SUBJECT: Documents encl B&WOG 890929 response to NRC 890807 request
 for addl info re NRC Bulletin 88-011, Item 1.b.

DISTRIBUTION CODE: IE30D COPIES RECEIVED: LTR 1 ENCL 1 SIZE: 2 + 29
 TITLE: Bulletin 88-11 Pressurizer Surge Line Thermal Stratification

Subject: Babcock & Wilcox Owners Group Response to NRC Bulletin
88-11, "Pressurizer Surge Line Thermal Stratification"

B&W Owners Group Responses to
NRC Questions on BAW-2085

Figure 1

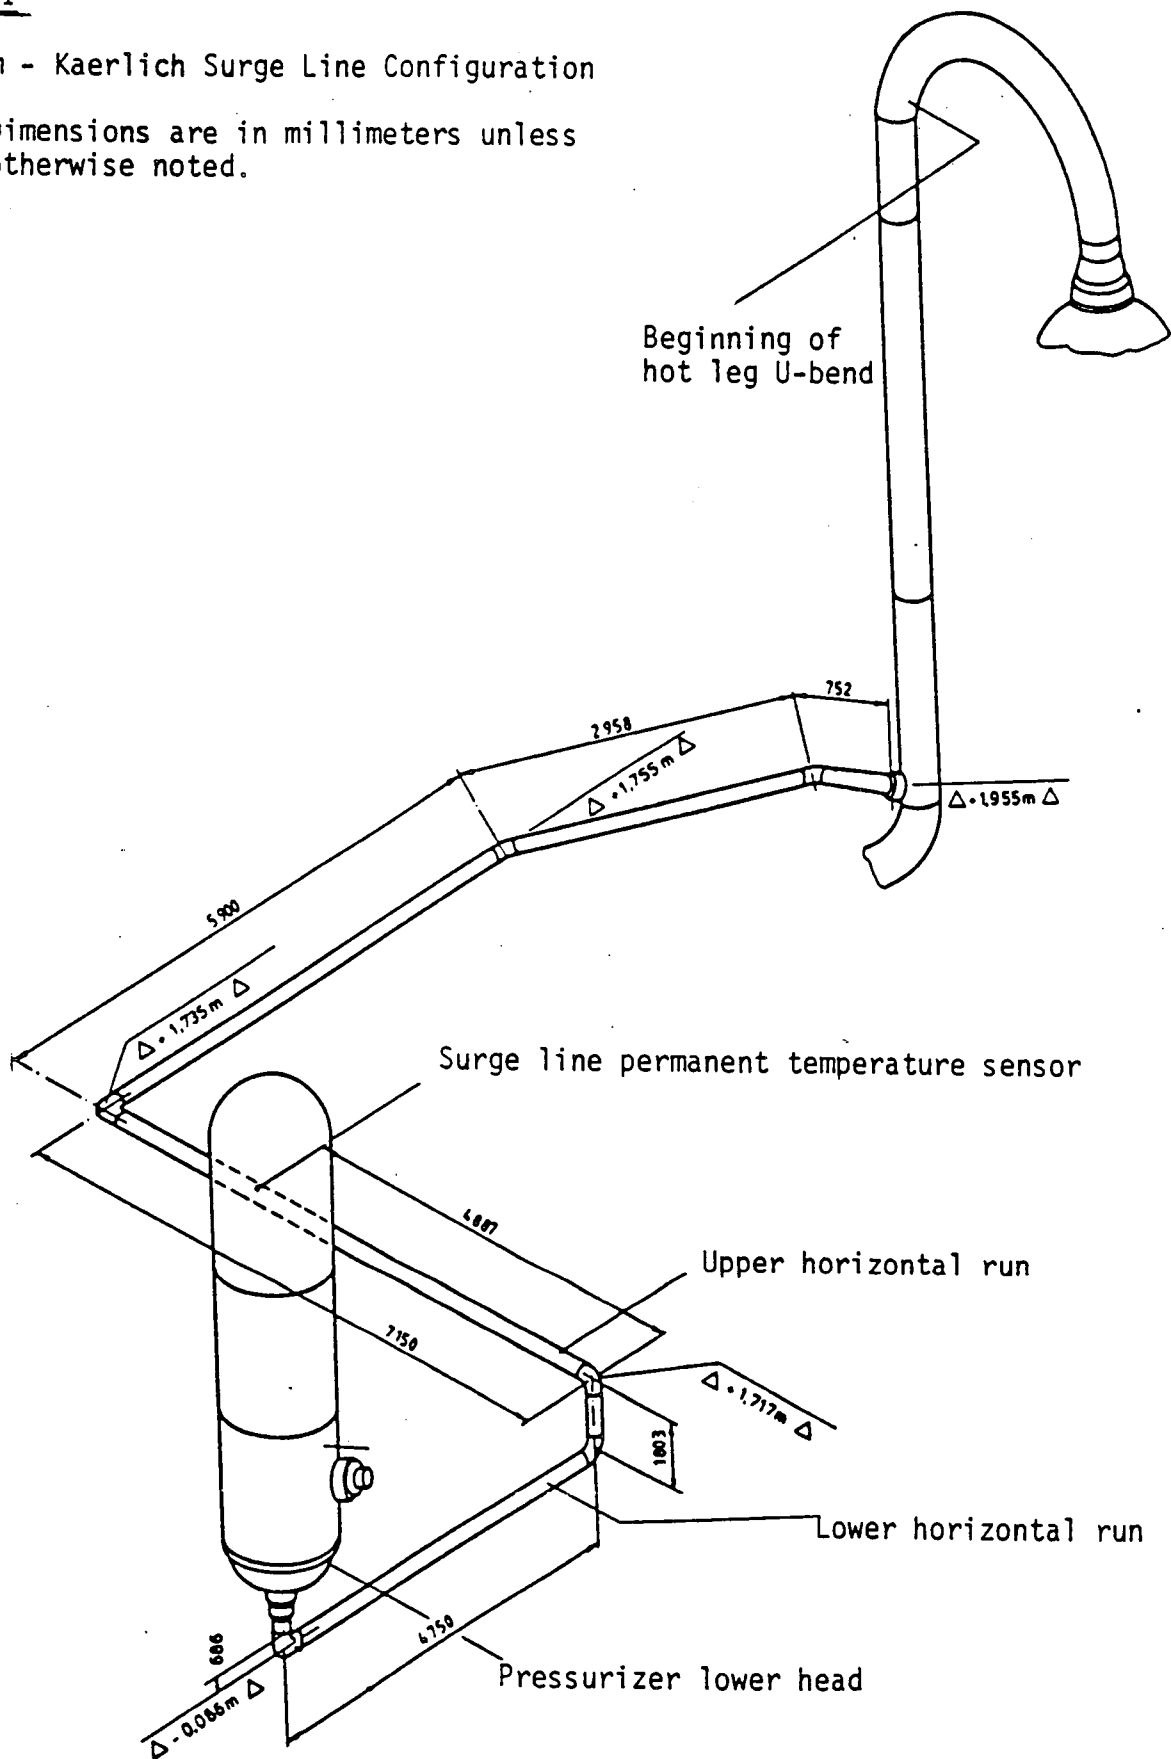
What are the specific differences between the Muelheim-Kaerlich (M-K) plant and the domestic plants?

The M-K plant is a two-loop pressurized water reactor (PWR) with two cold legs in each loop, each with its own reactor coolant pump. The plant employs a pressurizer and associated spray line and surge line functionally similar to typical U.S. PWRs.

The M-K plant's surge line dimensions and configuration are somewhat different from the domestic 177 fuel assembly plants' surge lines. BAW-2085 includes the specific information for the dimensions and configuration of the domestic plant surge lines. Figure 1 shows the M-K surge line configuration. The total line length at M-K is approximately 78 feet compared to about 50 feet for the domestic plants. The M-K configuration also contains a vertical rise in the line about 16 feet away from the pressuri-

zer, somewhat similar to the configuration at the Davis-Besse plant. However, the upper horizontal run at M-K is significantly longer than its counterpart at Davis-Besse.

The surge line inside diameter at M-K is approximately 15.7 inches versus 8.75 inches on the domestic plants. The straight pipe wall thickness at M-K is 1.8 inches versus the domestic plant value of 1 inch. M-K has removable stainless steel insulation on the surge line similar to that manufactured by B&W and used on most of the domestic surge lines.
